REPLACING PAGE ADDENDUM

**302B POWER PLANT
OPERATING METHODS**

1.001 This addendum supplements Section 167-622-301, Issue 2, the attached pages must be inserted in accordance with the filing instructions above.

1.002 This addendum is issued to correct an error in paragraph 1.04 and to correct Fig. 5 and 6.

Fig. 5—Normal Load—G1, G2, and G3 Supplying Load and Recharging Main Battery and GR1 EM Cells

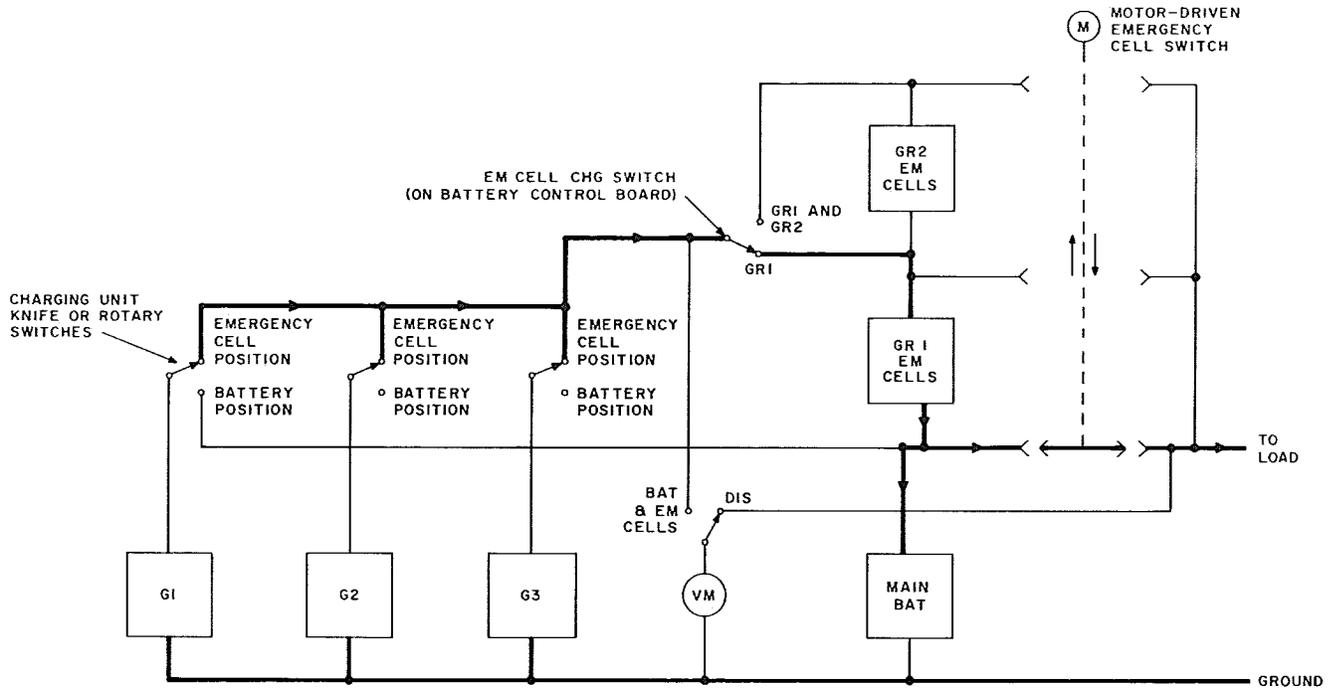
(a) Fig. 5—revised.

Fig. 6—Normal Load—GR1 EM Cells Recharged by G1—G2 and G3 Supplying Load and Floating Main Battery

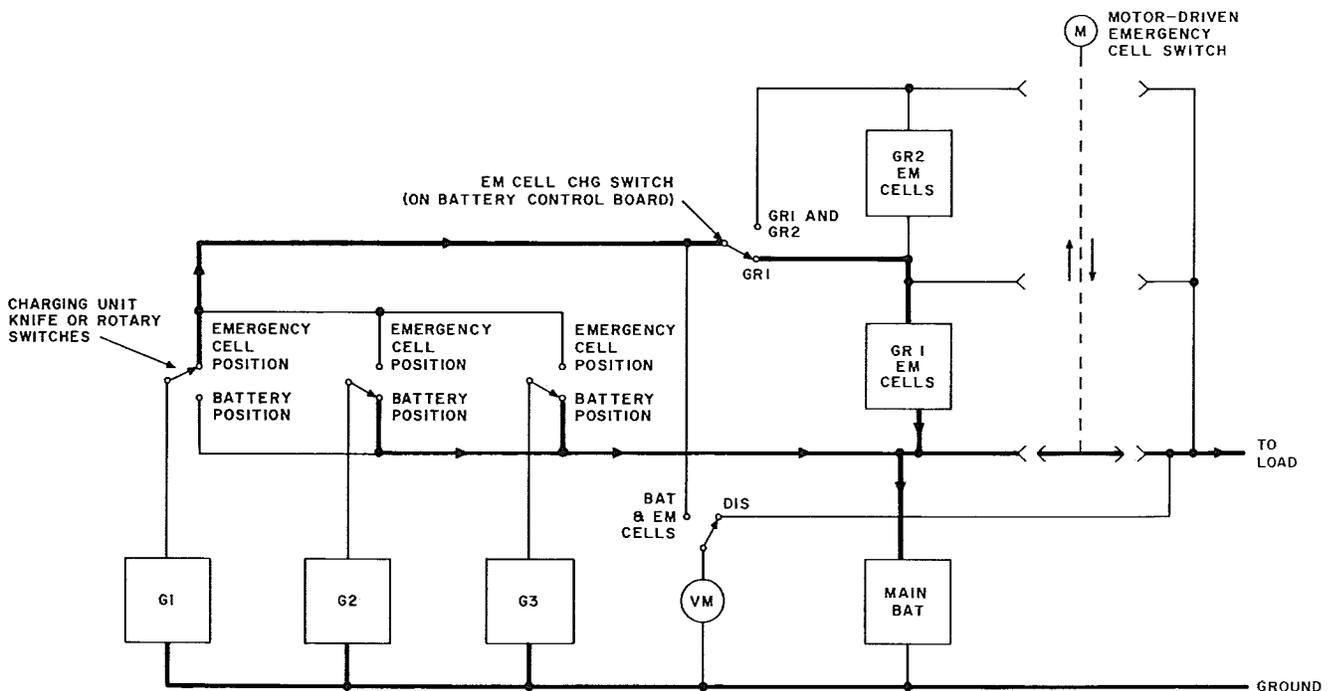
(b) Fig. 6—revised.
